CMB Meeting Minutes #175

REFERENCE Project No. M544.1, Contract No. 149 Task 1-8.02

SUBJECT: Configuration Management Board Meeting # 175 – Rev. No. 0

CONTRACT NO. 1252
 DRAWING NO. RP-150
 FILE NO. 91,680
 REV. NO. 0

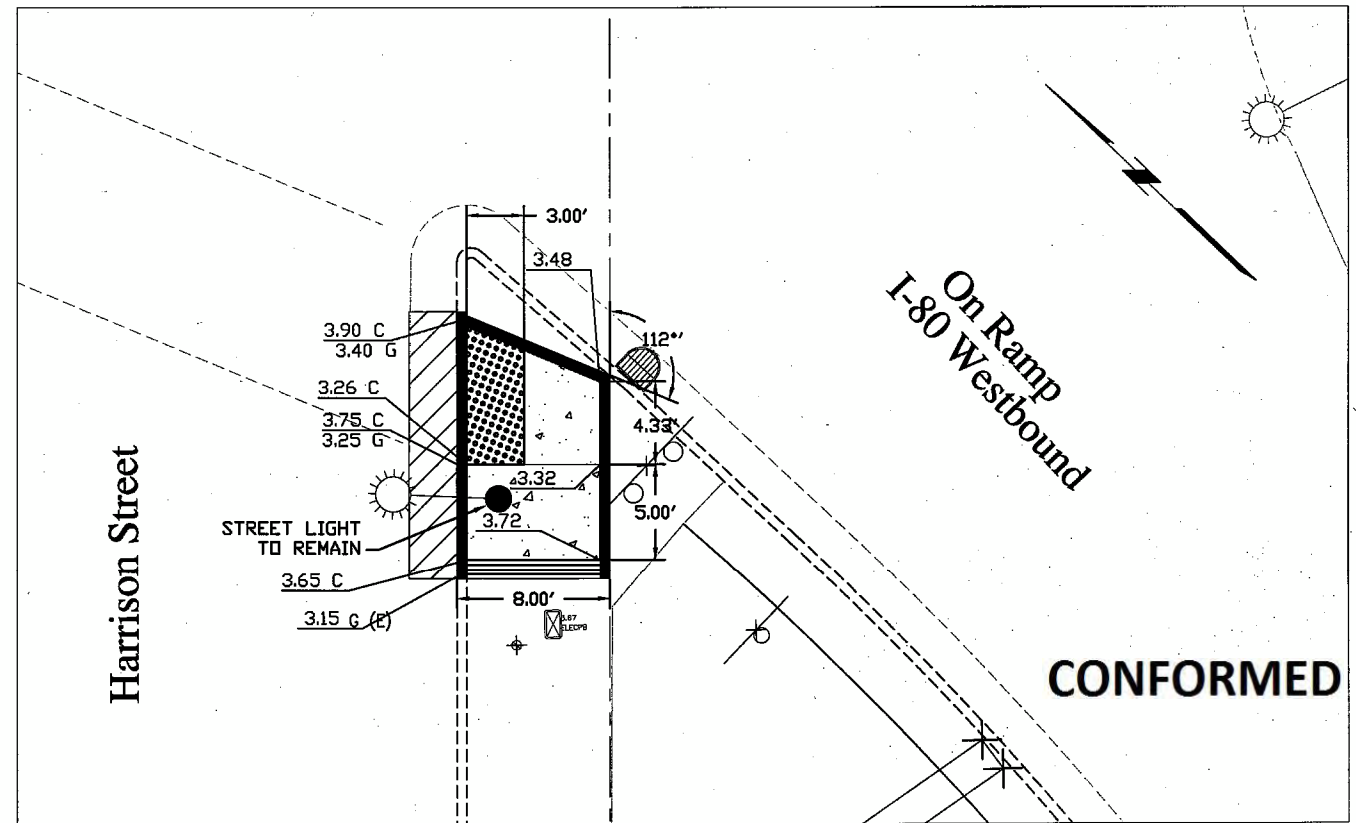
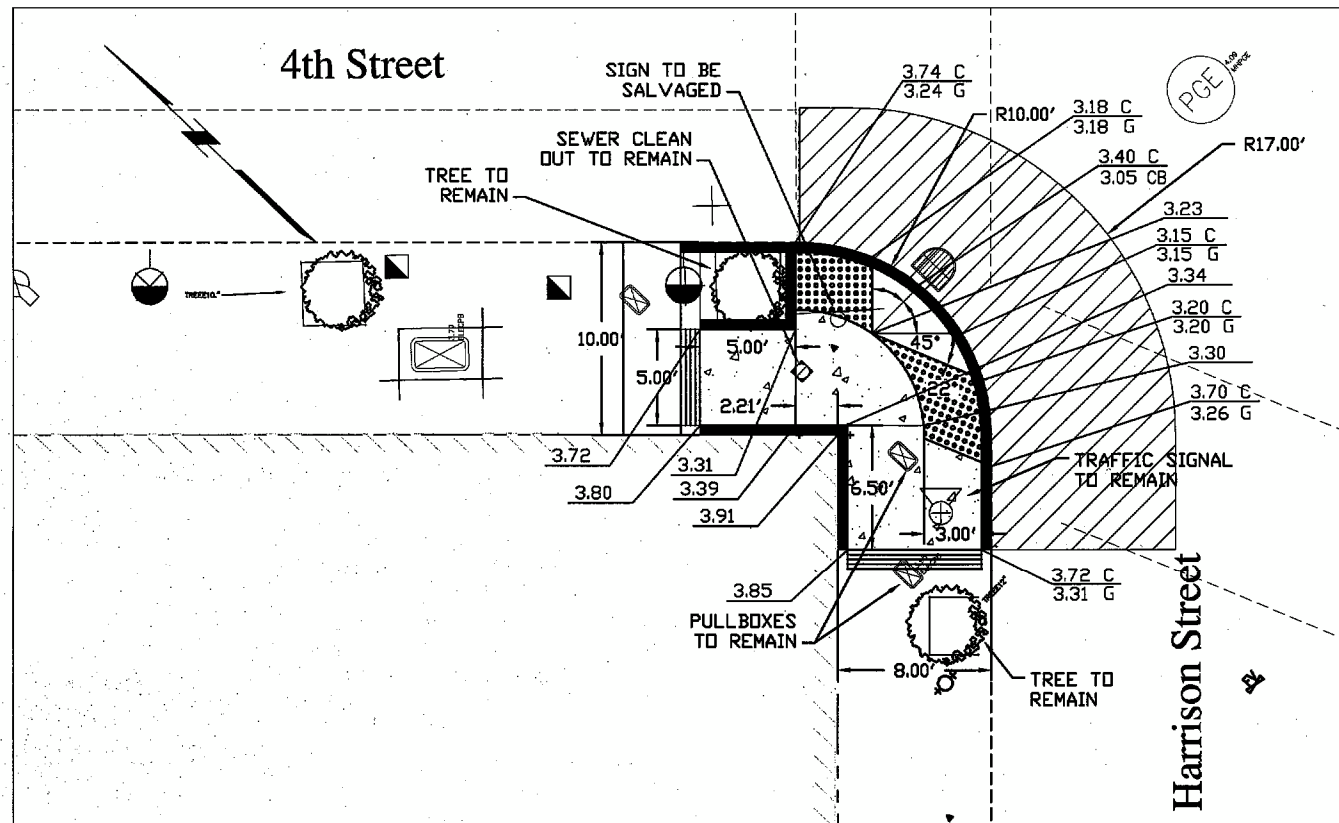
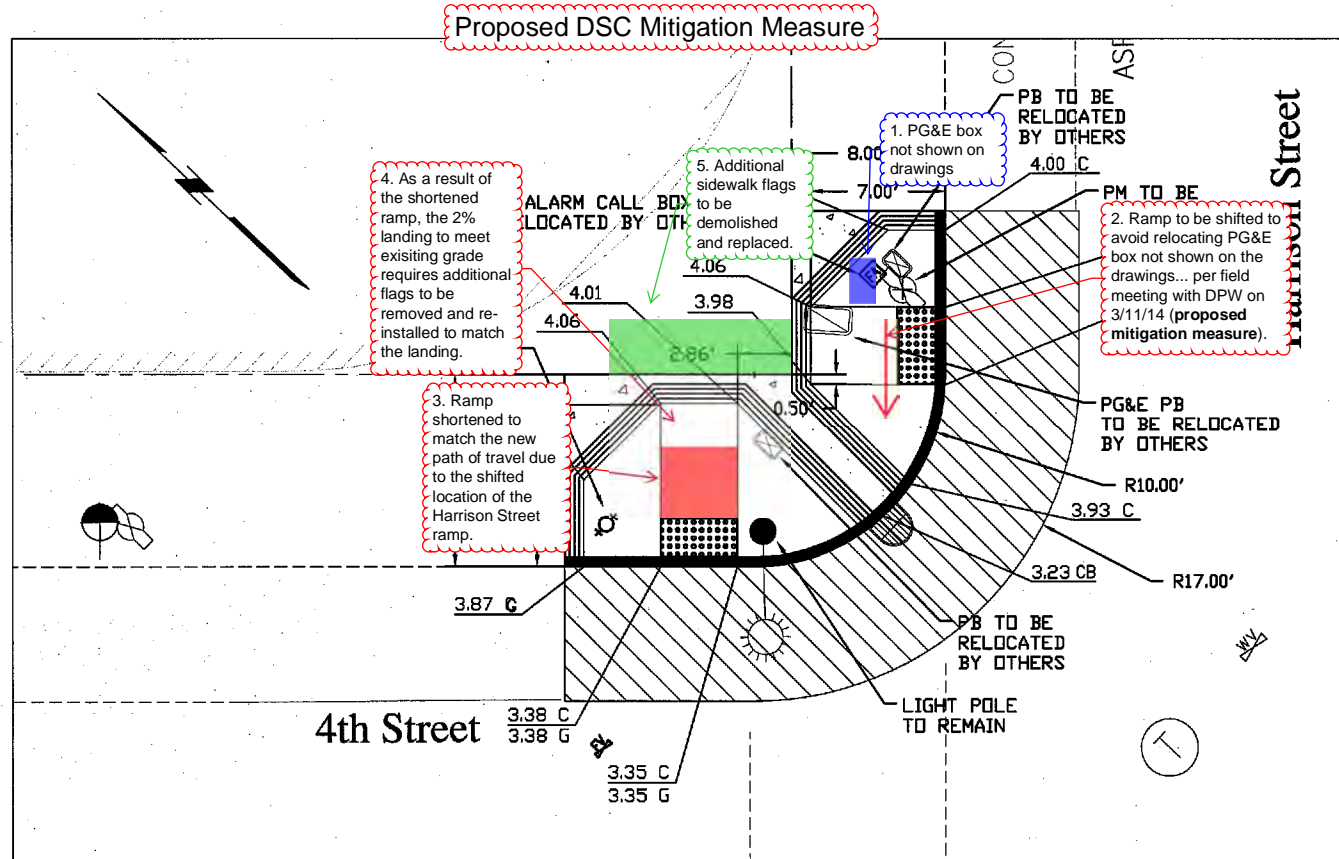
Existing cast-in-place PG&E pull box discovered in footprint of curb ramp to be installed per base Contract. Presence of pull box prevents installation of curb ramp according to Contract plans. Pull box not shown in Contract documents.

The conflicting ramp (Harrison Street side) will be shifted west to avoid conflict with the existing pull box. This shift will require the 4th Street ramp to be reduced in length. Five (5) flags of existing flat sidewalk (originally to remain per base Contract) will be replaced with sloped concrete in order to reach the revised ramp while not exceeding the maximum allowable slope for sidewalks/ramps.

CONTRACT NO. 1252
DRAWING NO. RP-150
FILE NO. 91,680
REV. NO. 0

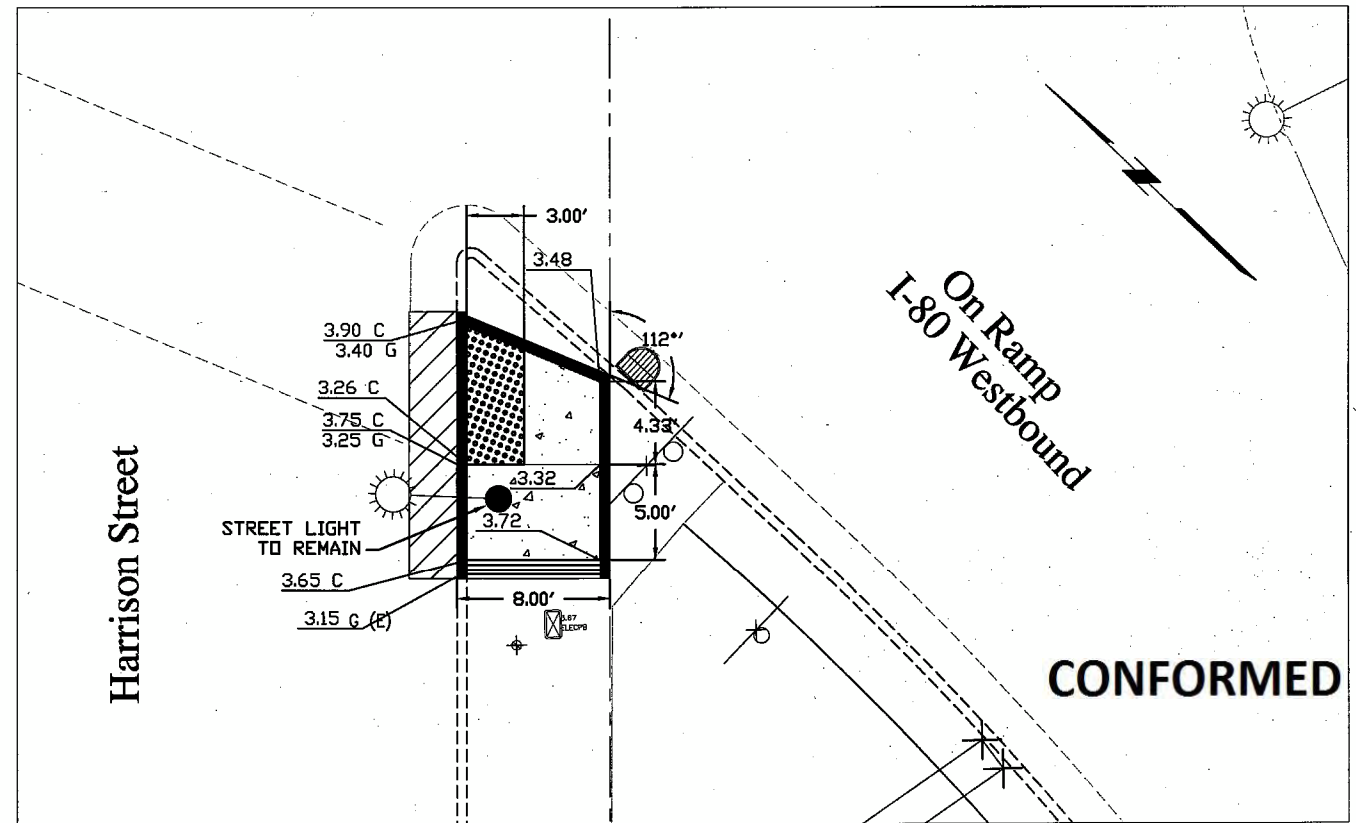
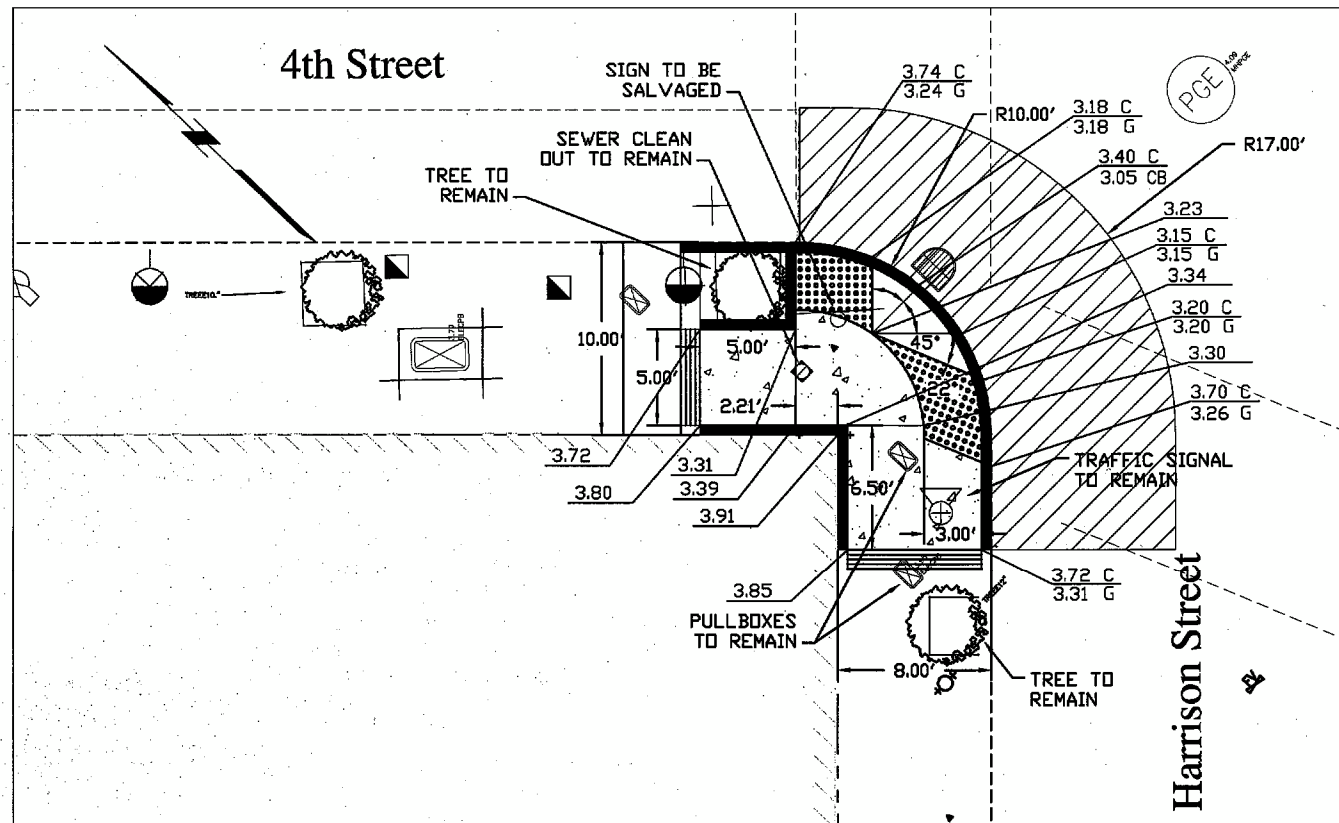
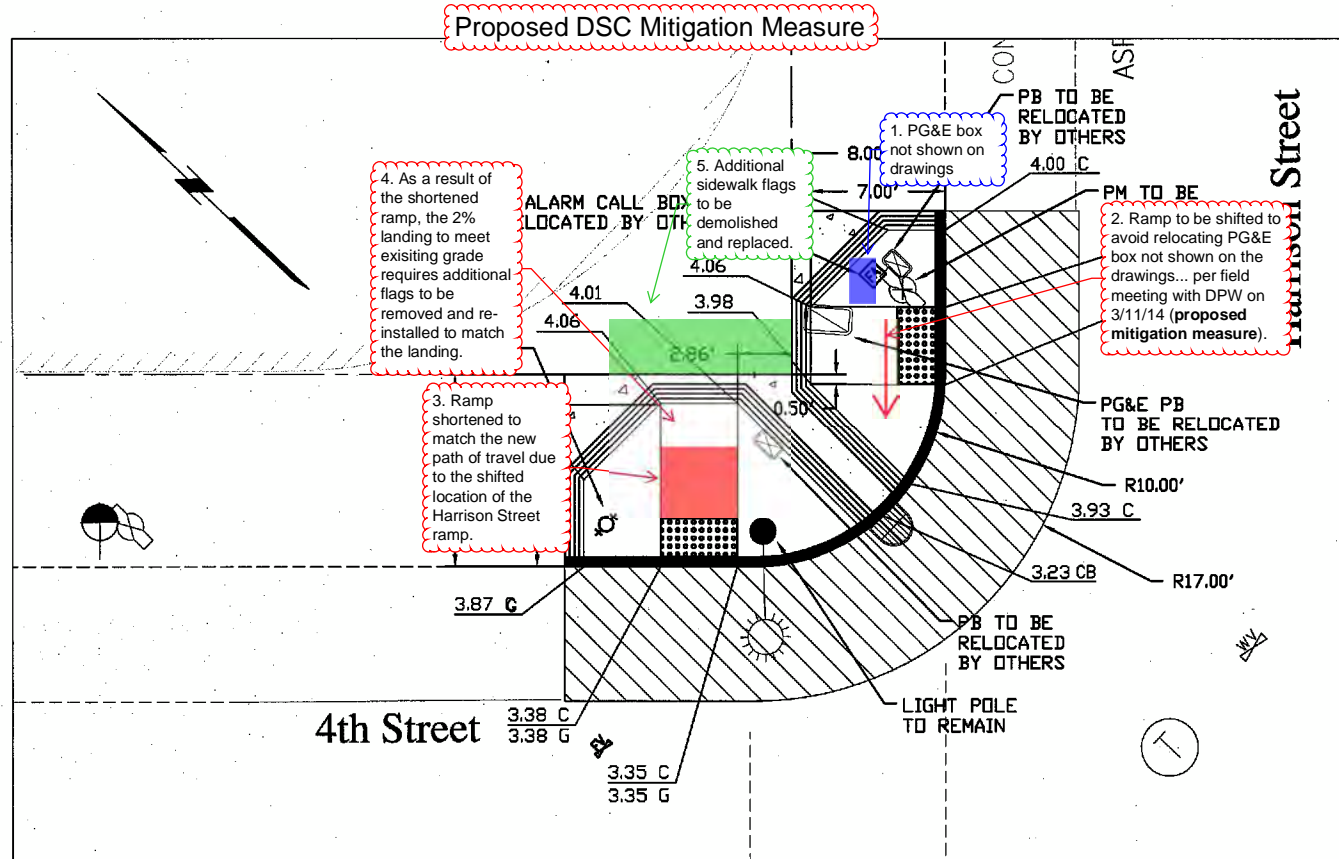
Install modified curb ramps and additional sidewalk flags as shown on drawing.
